SOUTHERN NEVADA AMENDMENTS TO THE 2024 INTERNATIONAL BUILDING CODE

Version Dated: July 21, 2026

FIGURE 1110.4.5.3
SIZE AND MANEUVERING CLEARANCES AT THE ADULT CHANGING SURFACE

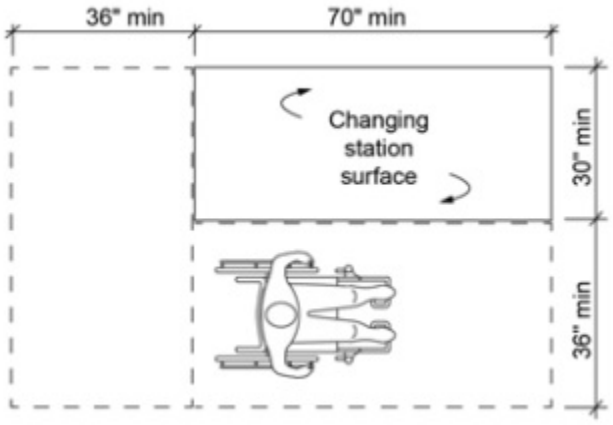
1110.4.5.3 Changing surface.
A changing surface shall be provided and shall comply with Section 1110.4.5.3.

1110.4.5.3.1 Size.
The changing surface shall be 70 inches (1778 mm) minimum in length and 30 inches (762 mm) minimum in width.
